Re: Adventist Healthcare, Long Branch Medical Building

LONG BRANCH MEDICAL BUILDING

RE: Long Branch Medical Building

RE: File Number - 1-06024 & 8-06008 -Long Branch Medical Building-Preliminary Plan and Site Plan

EXHIBIT 1

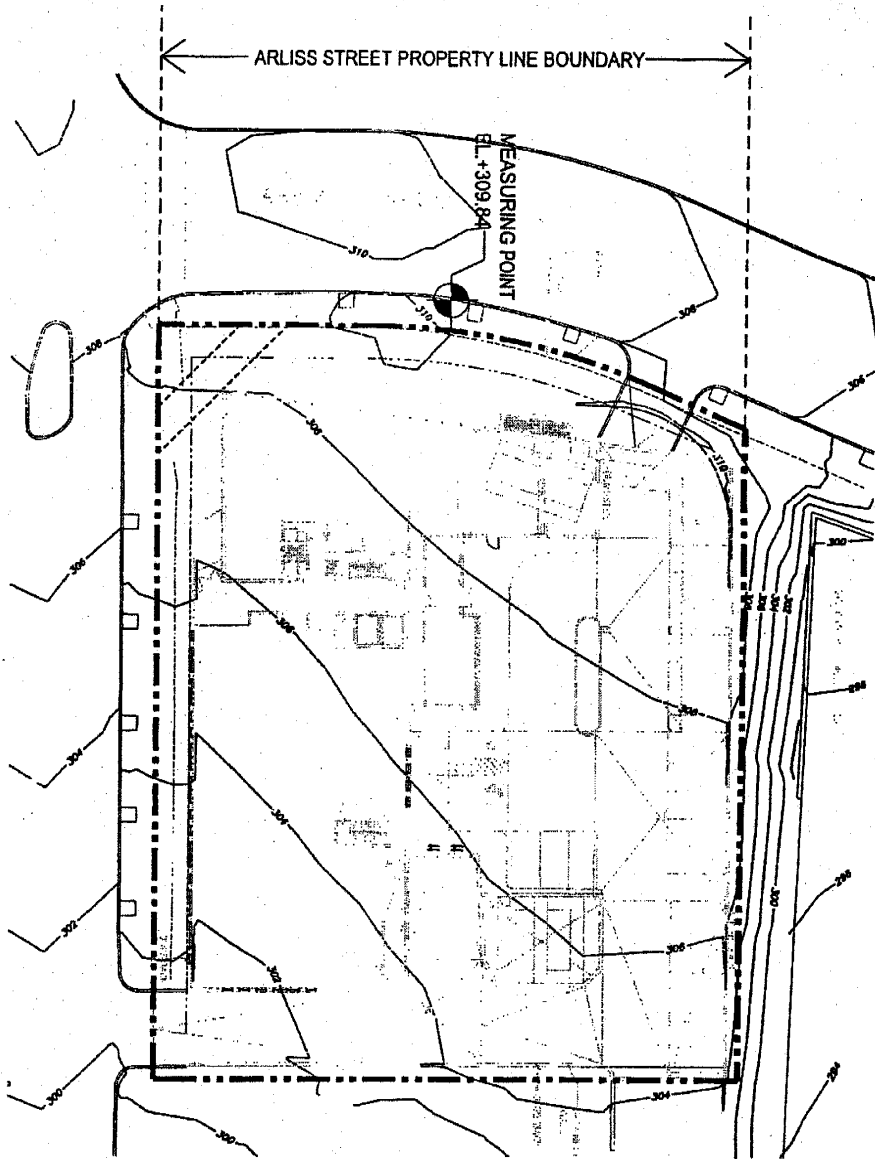
Per our meeting today, we have reviewed Shalom Baranes Associates' height methodology for establishing the measuring point for the site bounded by Flower Avenue and Arliss Street as shown in the two attached exhibits. We agree that the measuring point for allowable building height shown at the top of curb at the midpoint of the site frontage facing Arliss Street is acceptable under Division 59-A-2, Section 59-A-2.1 of the Zoning Code (Exhibit 1). The grade elevation at this point is indicated at +309.84'.

EXHIBIT 2

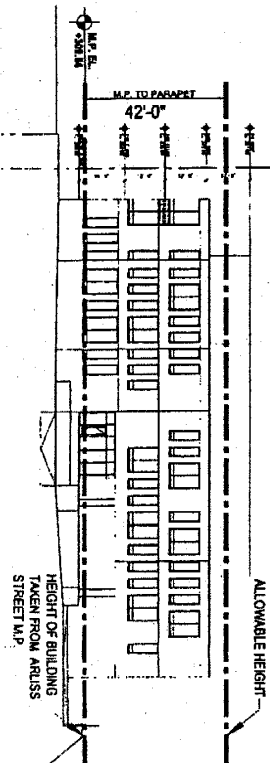
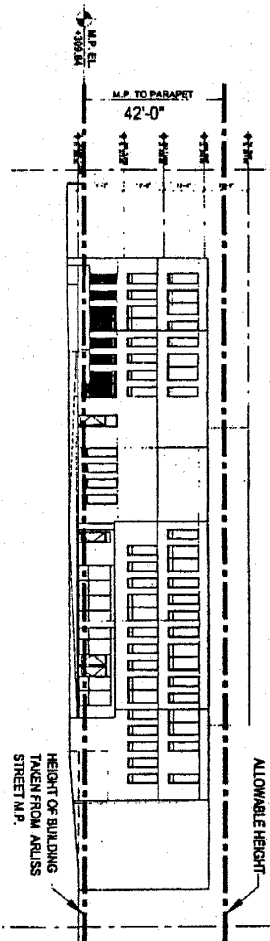
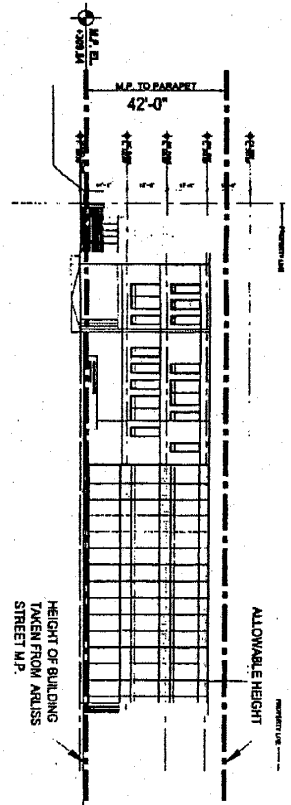
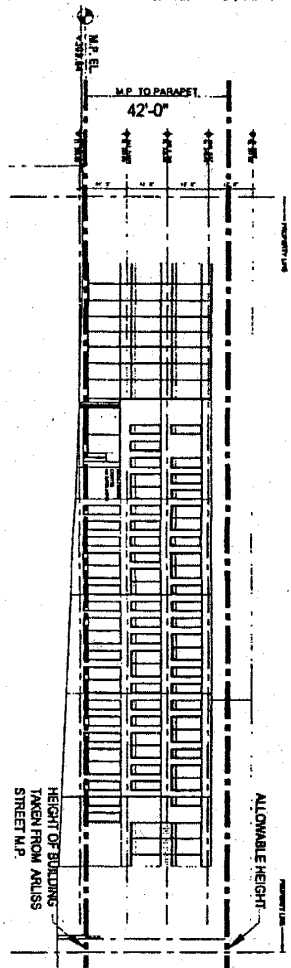
Subject to approval by the Planning Board, the allowable building height is 42 feet measured to the high point of the flat roof as taken from the established measuring point on Arliss Street (Exhibit 2).
